Sensors & Controls Division

June, 2005

Bourns® Model PDA17 Rotary Potentiometer Upgrade

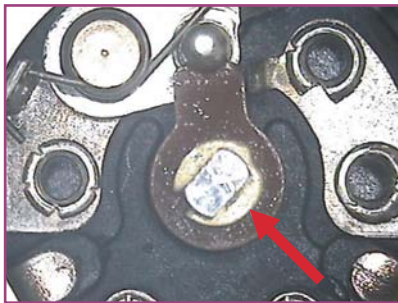
In line with our commitment to product excellence, Sensors & Controls introduces a product improvement to our popular [Model PDA17-SS](#) 17 mm Rotary Potentiometer. The product upgrade entails an assembly improvement of the shaft to the switch actuator. Please note that **this change affects the switch version of this product** only. The non-switch version is not affected.

As detailed in the photos below, the design upgrade eliminates the use of a c-clip to affix the switch actuator to the shaft. The new design incorporates the use of a riveting process to firmly secure the switch actuator to the shaft.

Old design with c-clip

New design with rivet process

The changes to this product do not affect current compliance to RoHS requirements. This upgrade **does not affect, form, fit or function.**

Product with the improved design will begin shipping starting with date code 0519.
